Bulletin No.: 15822C  
Date: January 2017

# Recall Bulletin

**SUBJECT:** Seatbelt Lap Anchor Tensioner Cable – Driver’s Side

**MODELS:** 2014-2015 Chevrolet Silverado 1500 Series  
2014-2015 GMC Sierra 1500 Series

4522274

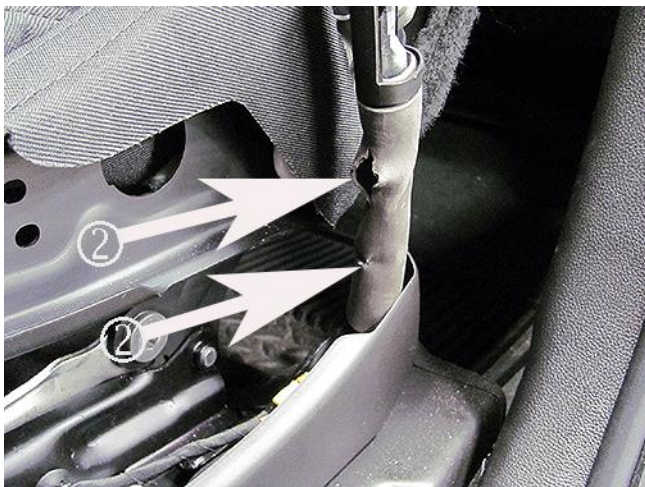
This damage will be in the form of holes (1) or splitting (2).

- If **any damage** is found, replace the tensioner while performing the bracket installation.
- If no damage is found, install the seat tensioner bracket using the existing tensioner.

4551062

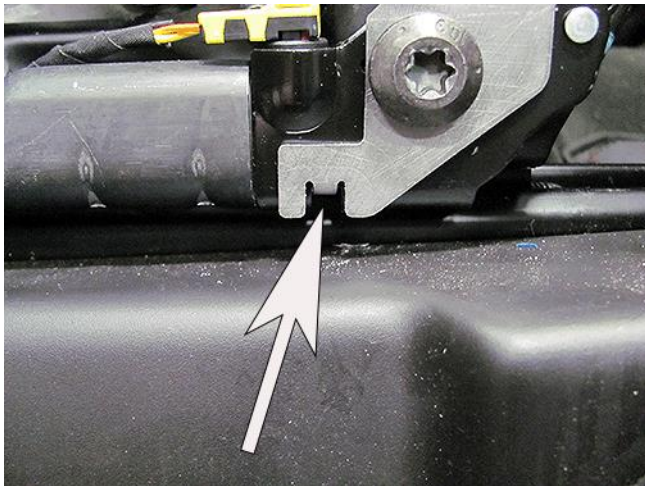
4. Ensure the tensioner cable is positioned on the outside of the tab on the bracket.

4551063

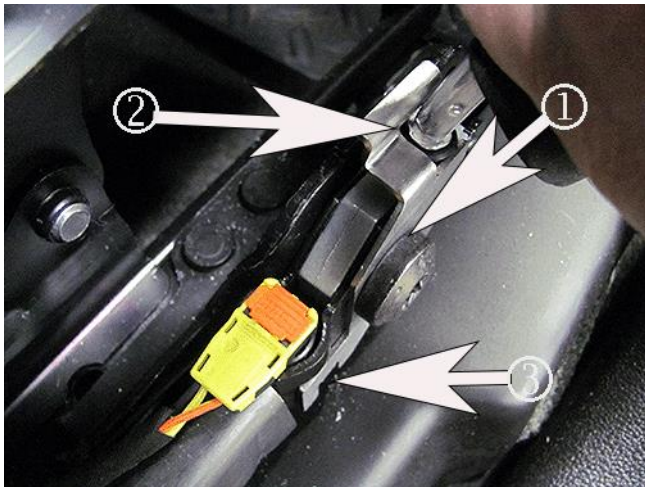
5. Assemble the tensioner assembly, service bracket and bolt.
